PEACH BOTTOM ATOMIC POWER STATION, UNIT NO. 2

AMENDMENT TO FACILITY OPERATING LICENSE

Amendment No. 86  
License No. DPR-44

SAFETY EVALUATION BY THE OFFICE OF NUCLEAR REACTOR REGULATION  
SUPPORTING AMENDMENT NO. 86 TO FACILITY OPERATING LICENSE NO. DPR-44

FIGURE 3.5.K.1 MCPR OPERATING LIMIT vs  $T$

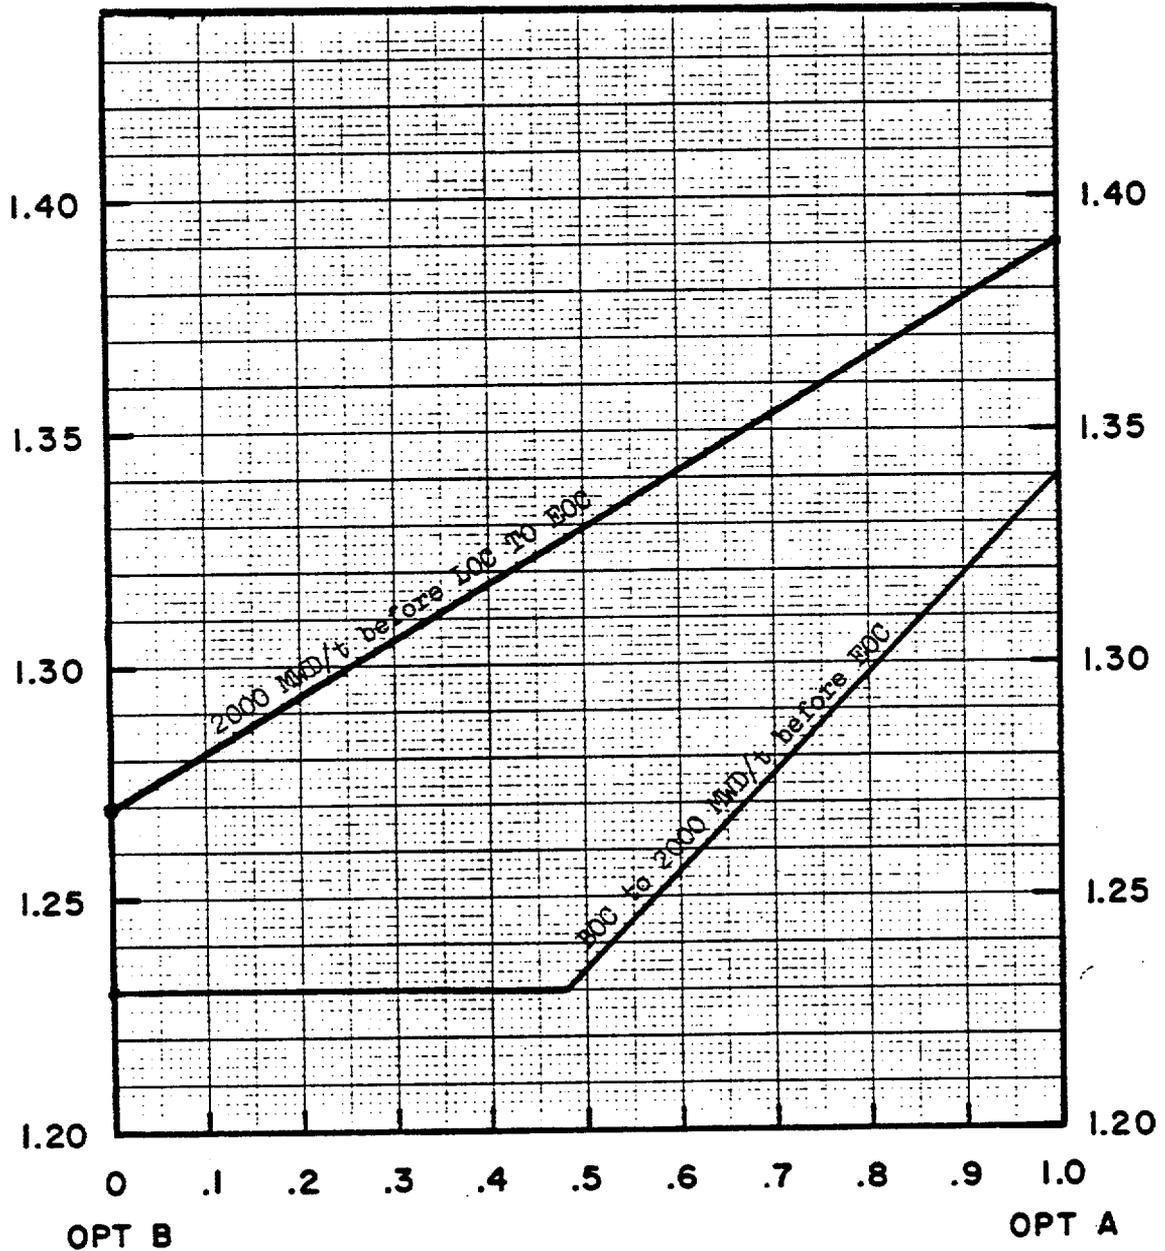
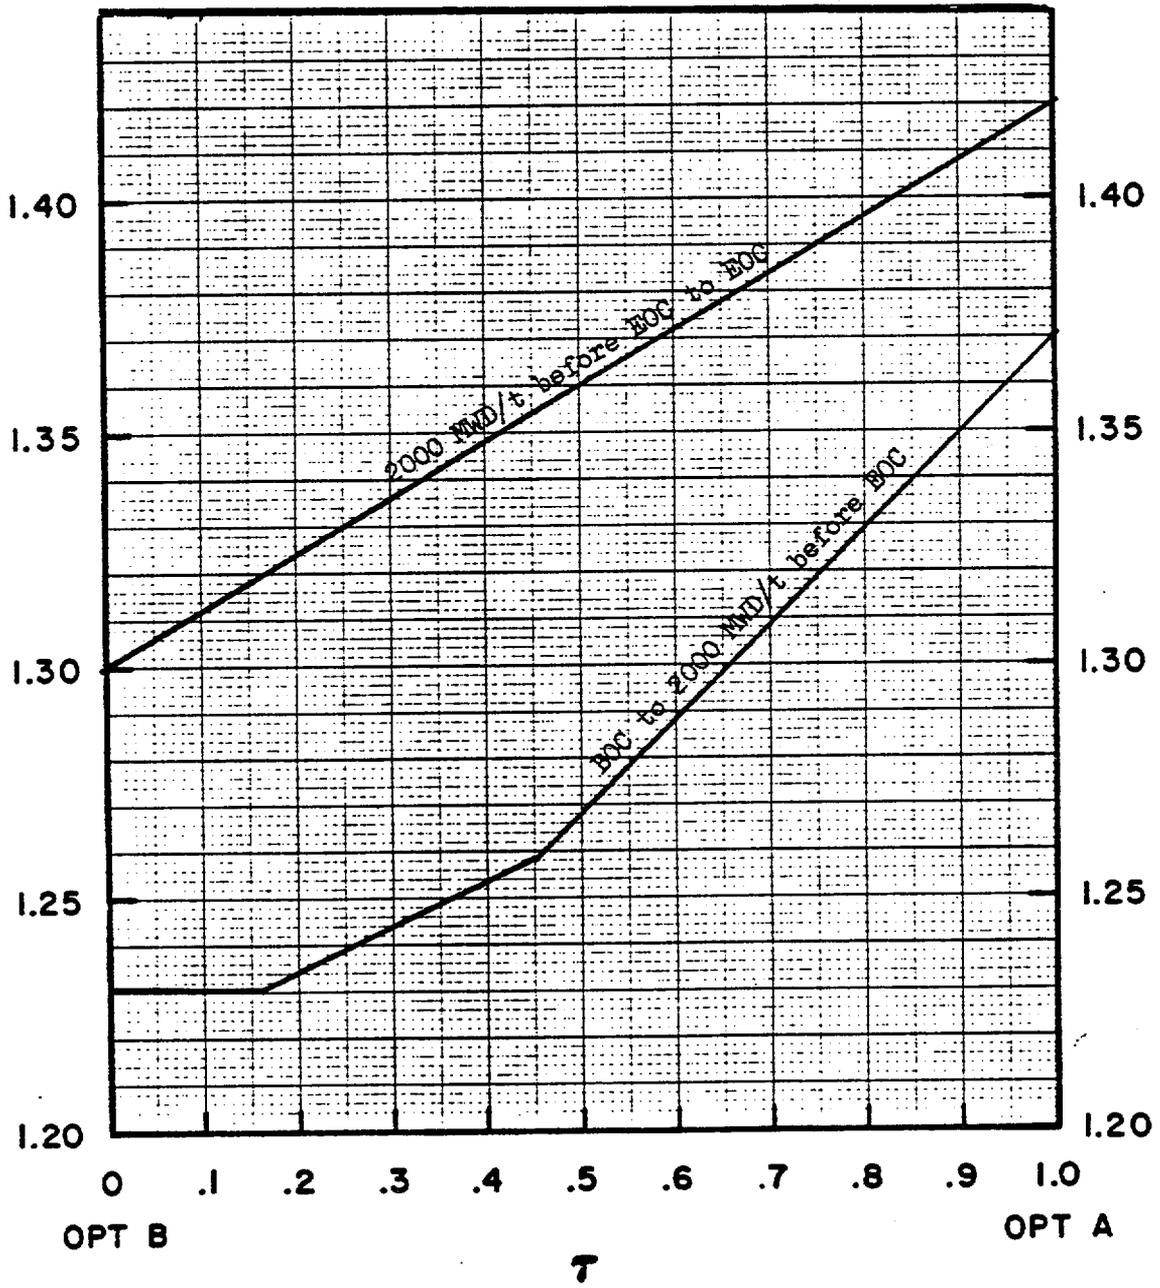
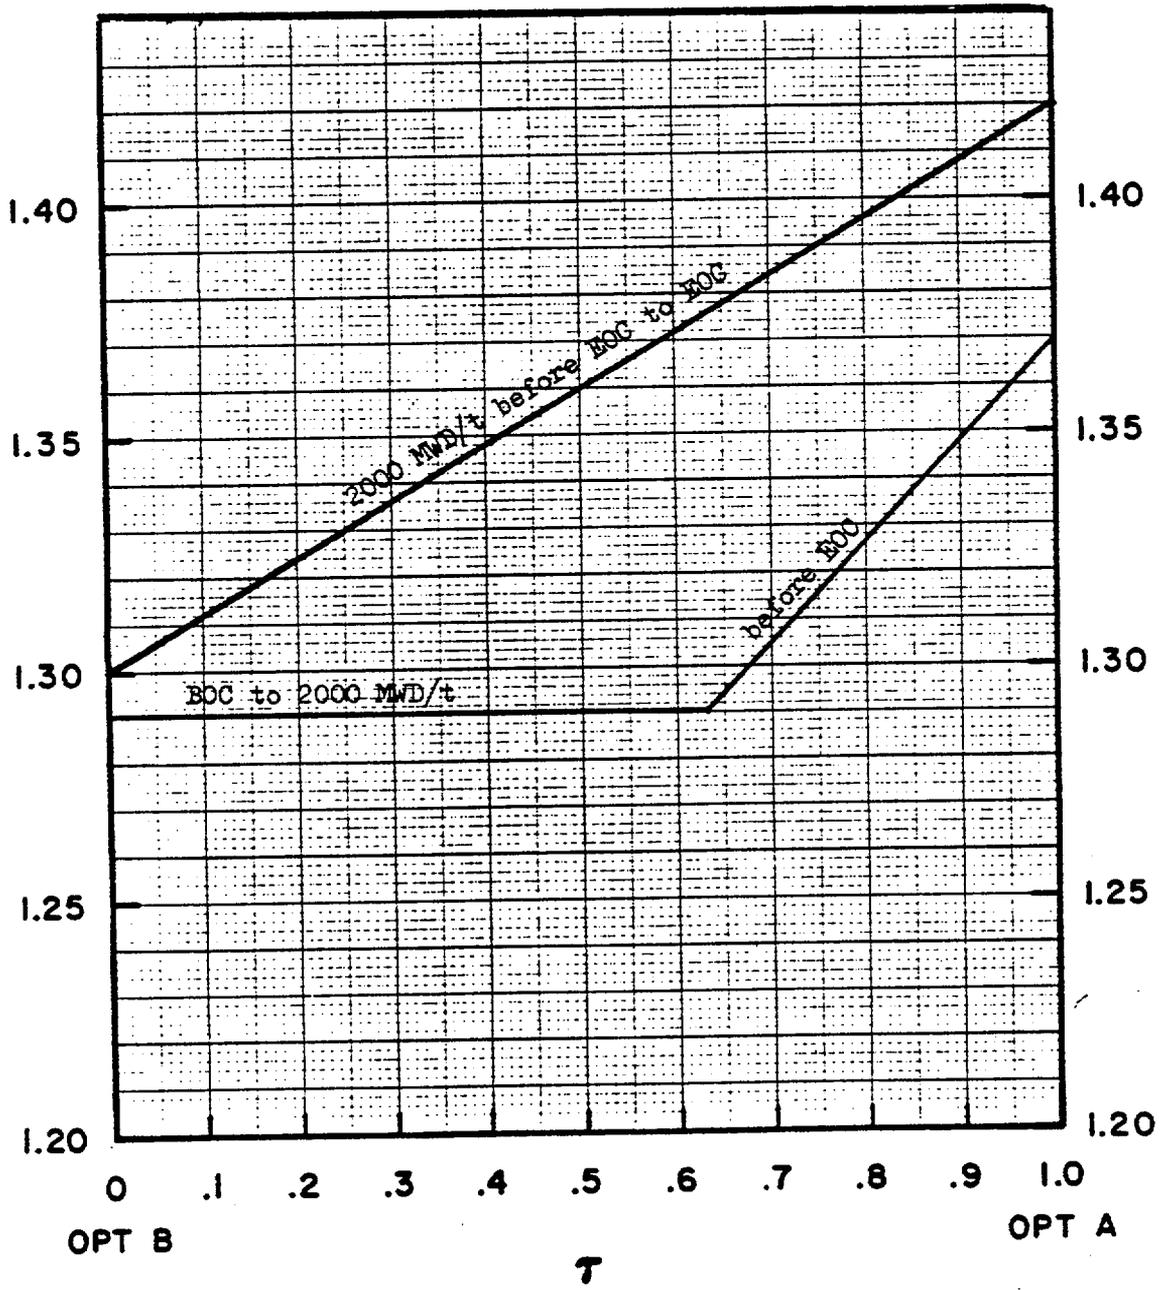
The operating limit MCPR Technical Specification has been modified to include an Option B format where the operating limit MCPRs vary with the measured scram time ( $\tau$ ). The specification is based on measurements to the 20 percent inserted position. Figures 3.5.K.1, 3.5.K.2 and 3.5.K.3 of the proposed Technical Specifications show operating limit MCPR vs  $\tau$  for 8x8 LTA, P8x8R and P8DRB285 fuels, respectively.

The licensee has performed the required analyses. As a consequence of using more than one code (ODYN and REDY) for the transients and the two options available with ODYN (Option A with straight penalty for uncertainties and Option B with statistical convolution of uncertainties and rod scram times), the limiting transient for Peach Bottom-2 is dependent upon periodic on-site measurements of average scram time. Depending upon the measured average scram time, the MCPR operating limit will change as shown on TS Figures 3.5.K.1, 2 and 3.

b. If requirement 4.5.K.2.a is not met:  
The Operating Limit MCPR values as a function of  $\tau$  are as given in Figures 3.5.K.1, 3.5.K.2, and 3.5.K.3.

FIGURE 3.5.1.G Maximum Average Planar Linear Heat Generation Rate Versus Planar Average Exposure

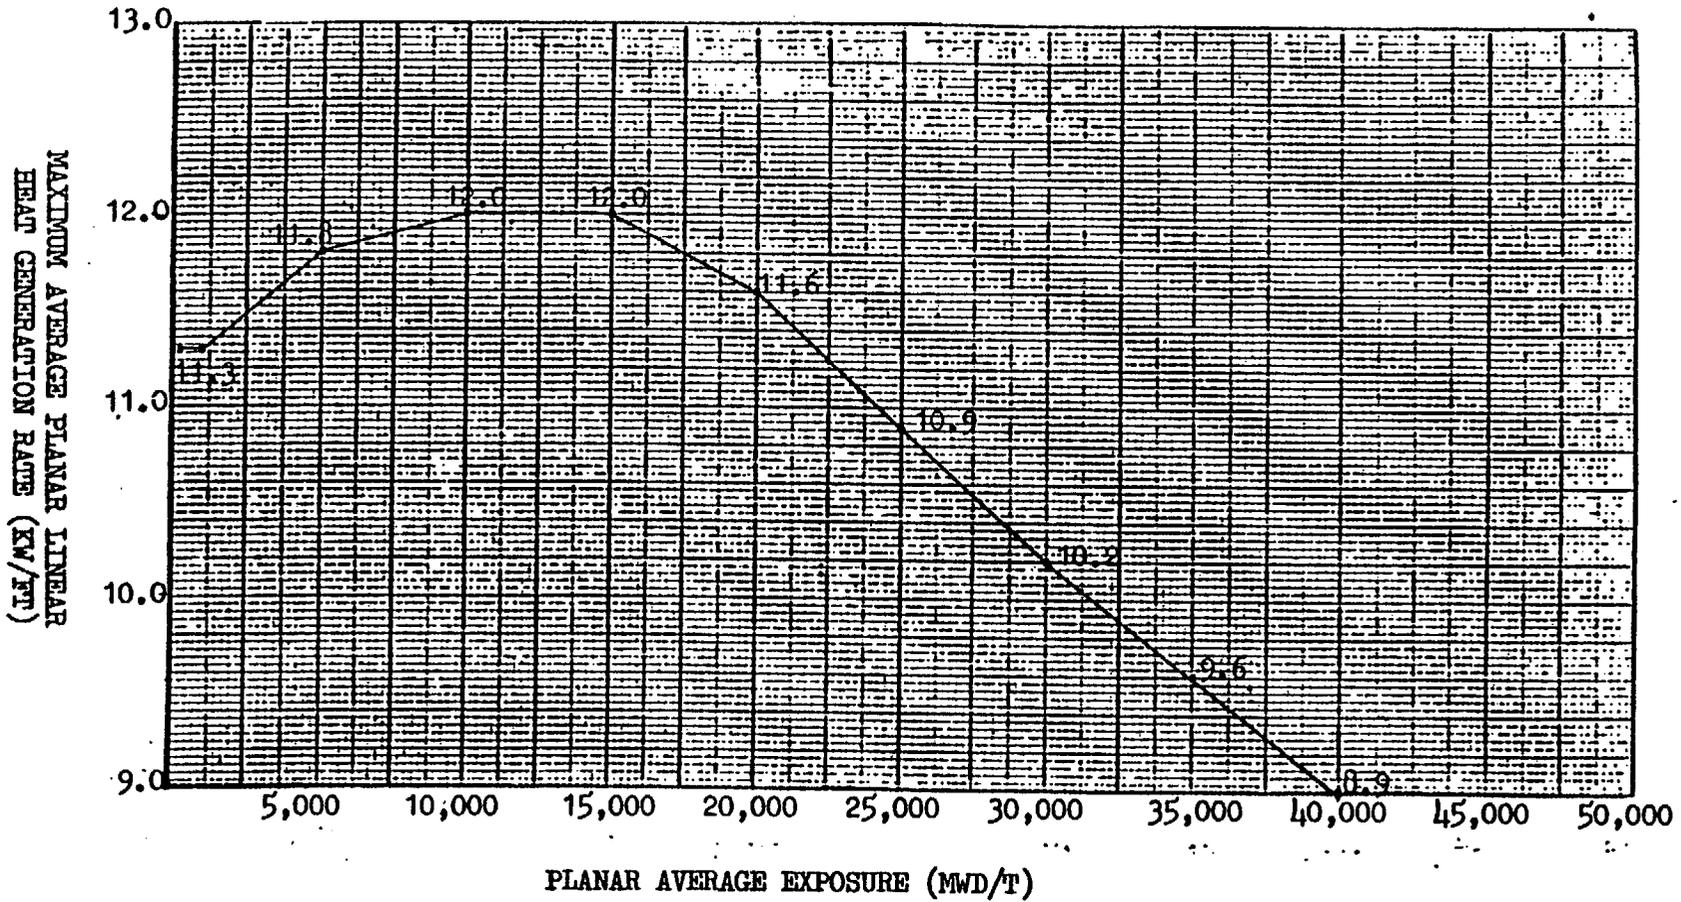
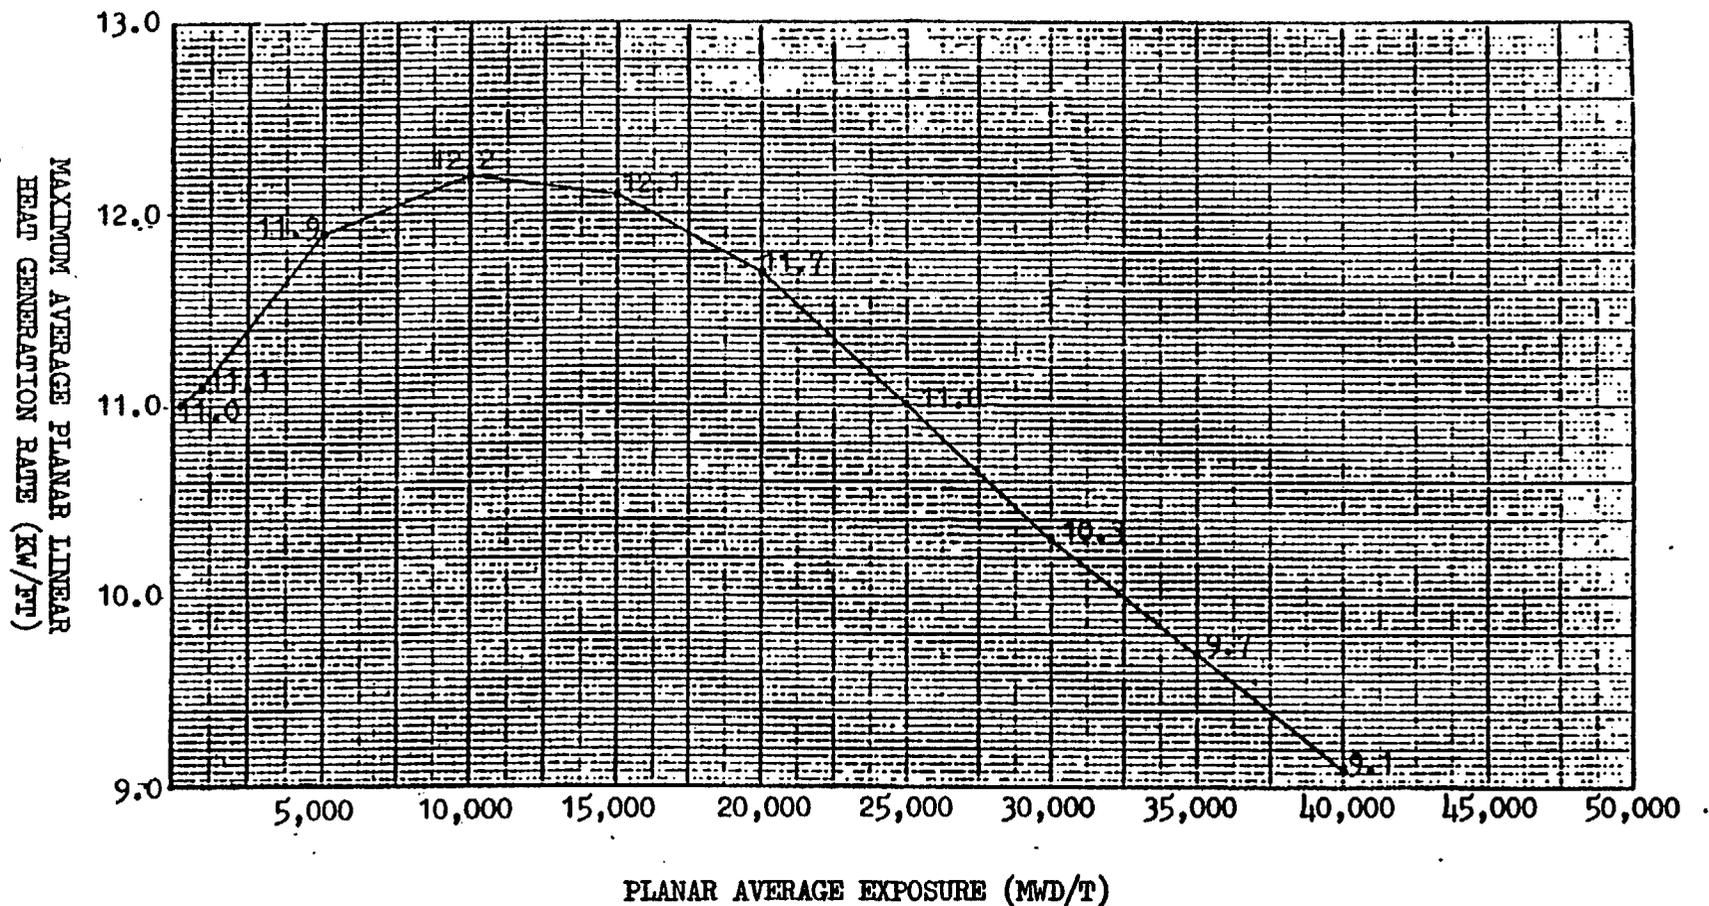
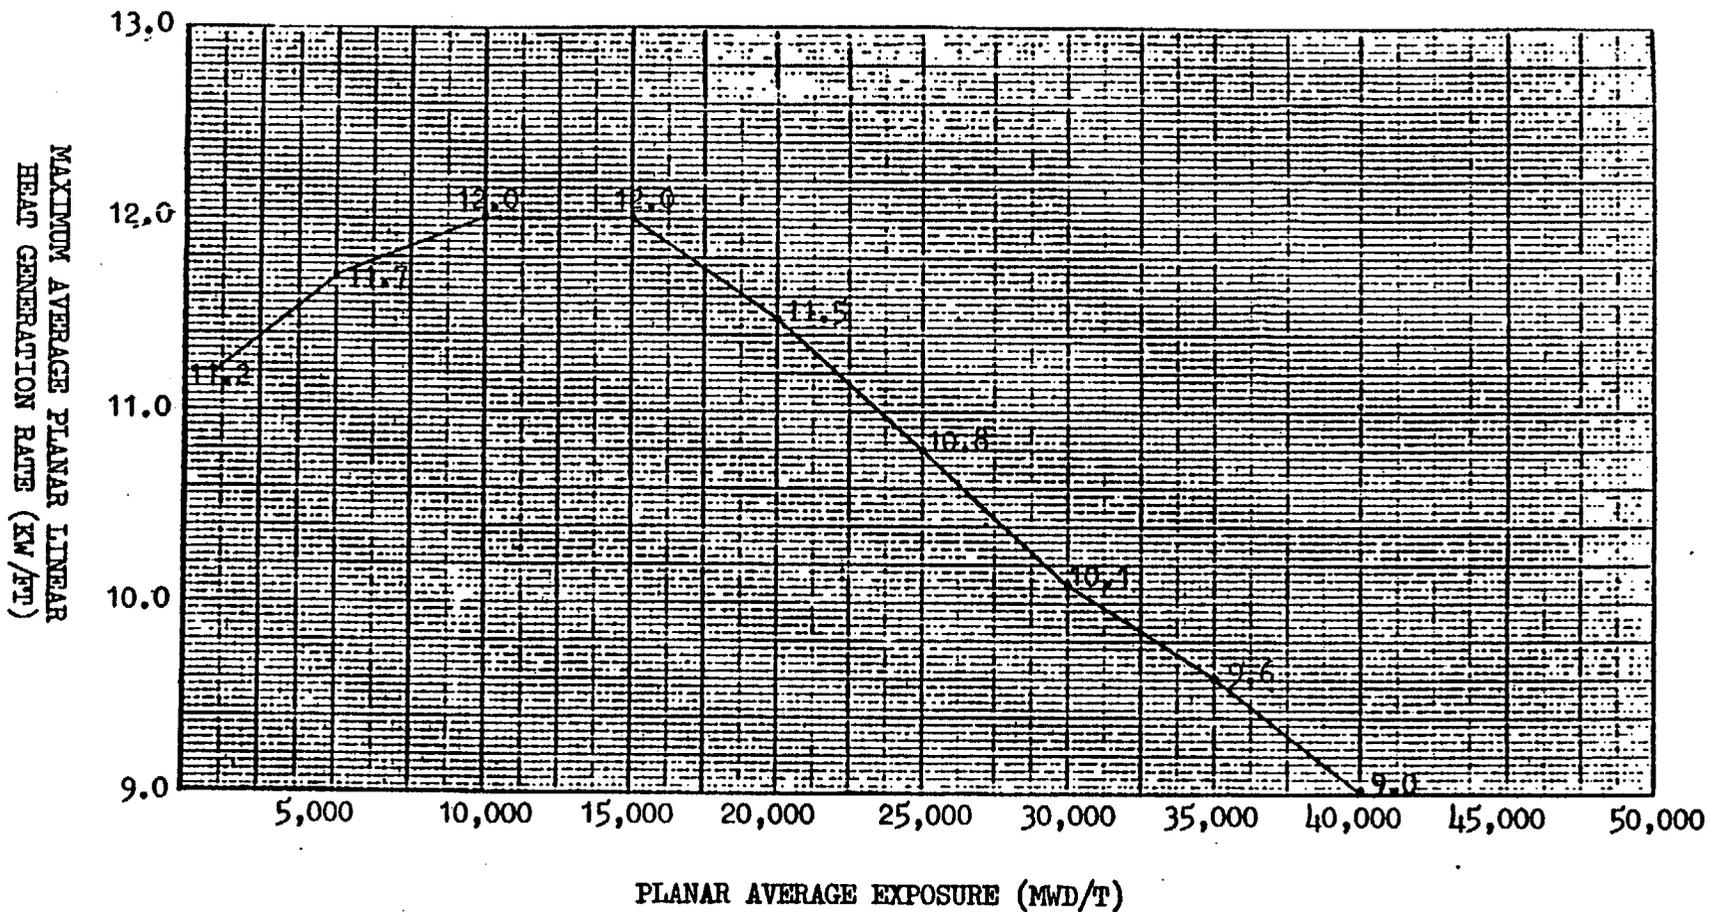
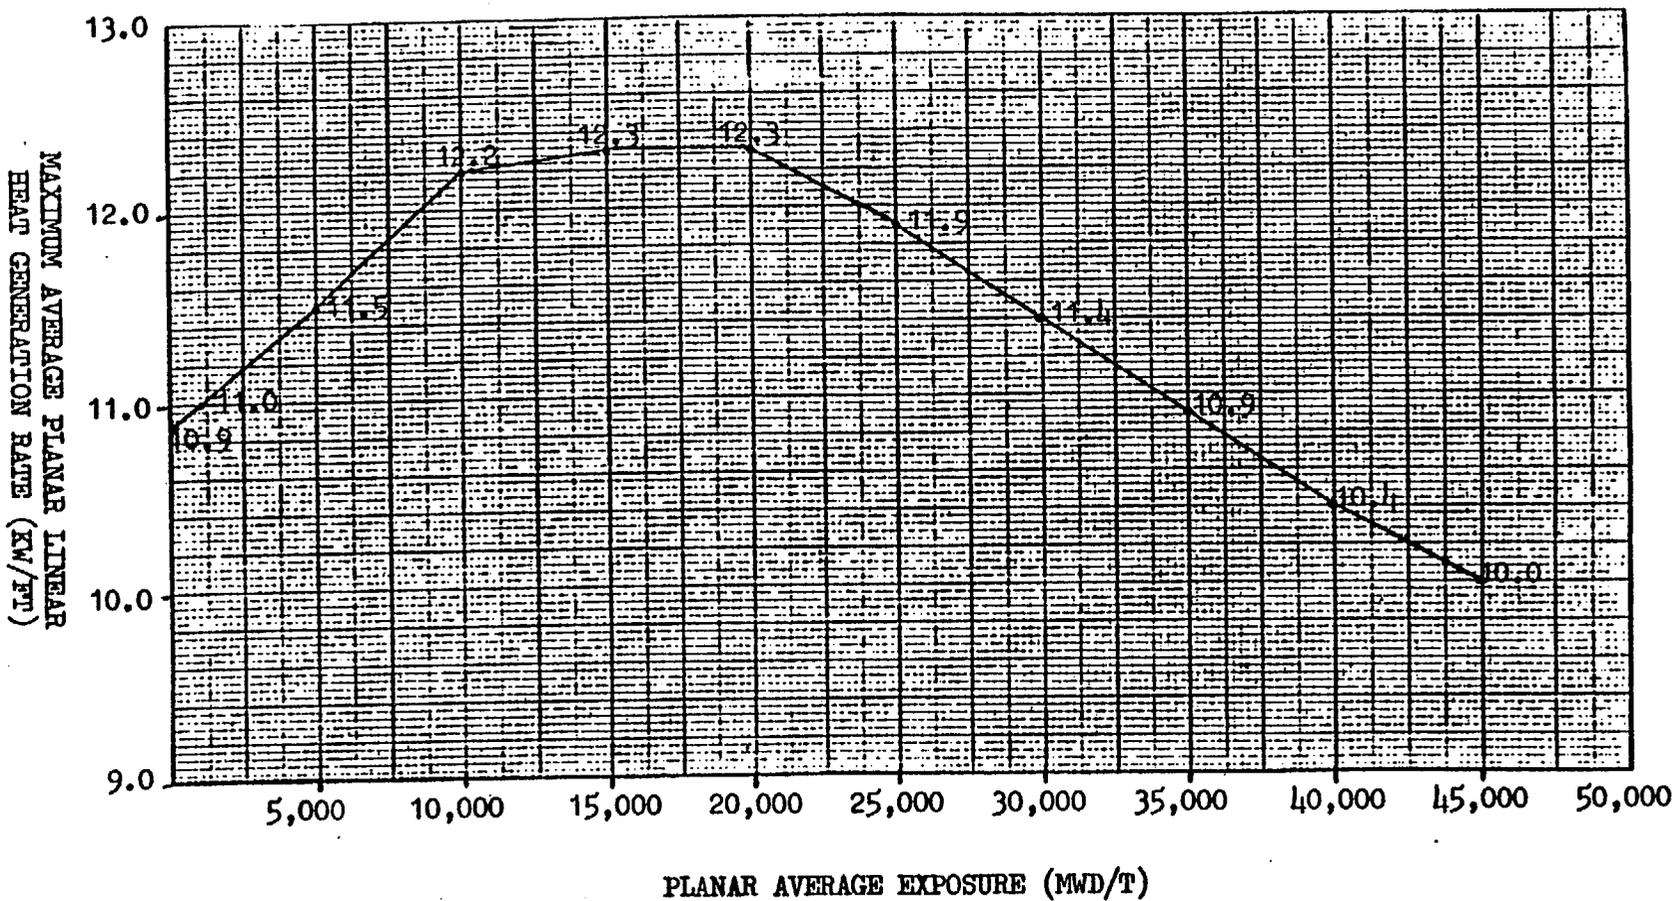
The licensee has submitted new and revised MAPLHGR limits for all Cycle 6 fuel types including extended exposure limits for standard and LTA fuel. These limits were generated by methods (Ref. 7) submitted as part of the application. Although the methodology used is generally applicable for these limits, we believe that the effects of enhanced fission gas release in high burnup fuel (above 20 Gwd/MtU) were not adequately considered in the generic analysis. In response to this concern, the General Electric Company requested (Refs. 8-9) that credit for approved, but unapplied, emergency core cooling system (ECCS) evaluation model changes be used to avoid MAPLHGR penalties at higher burnup.

This proposal was found acceptable (Ref. 10) provided that certain plant-specific conditions were met. In a letter dated July 15, 1981 (Ref. 11), Philadelphia Electric Company found the General Electric proposal applicable to both Peach Bottom Units 2 and 3. On the basis of this finding, we conclude that the MAPLHGR limits proposed for Peach Bottom Unit 2 Cycle 6 are acceptable.

It should be noted that these MAPLHGR limits have been provided for average planar exposures of up to 40 GWd/STU for all fuel types except the two LTAs, which have MAPLHGR limits specified for average planar exposures of up to 50 GWd/STU. We regard these proposed Technical Specifications as limiting on both power and burnup, and therefore the peak planar average exposure during Cycle 6 operation must be limited to 40 GWd/STU for all but the two LTAs by the proposed Technical Specifications. It should also be noted that a basis for MAPLHGR extensions beyond 40 GWd/STU average planar exposure has not yet been accepted by the NRC staff for other than LTA operation. A General Electric submittal that would justify such high-burnup application is expected in the near future. However, communication with the licensee has revealed that average planar exposures beyond 40 GWd/STU are not anticipated for 8DRB284L fuel and, therefore, such a submittal is not required to support the Cycle 6 safety analysis. We thus find the MAPLHGR limits acceptable as submitted.
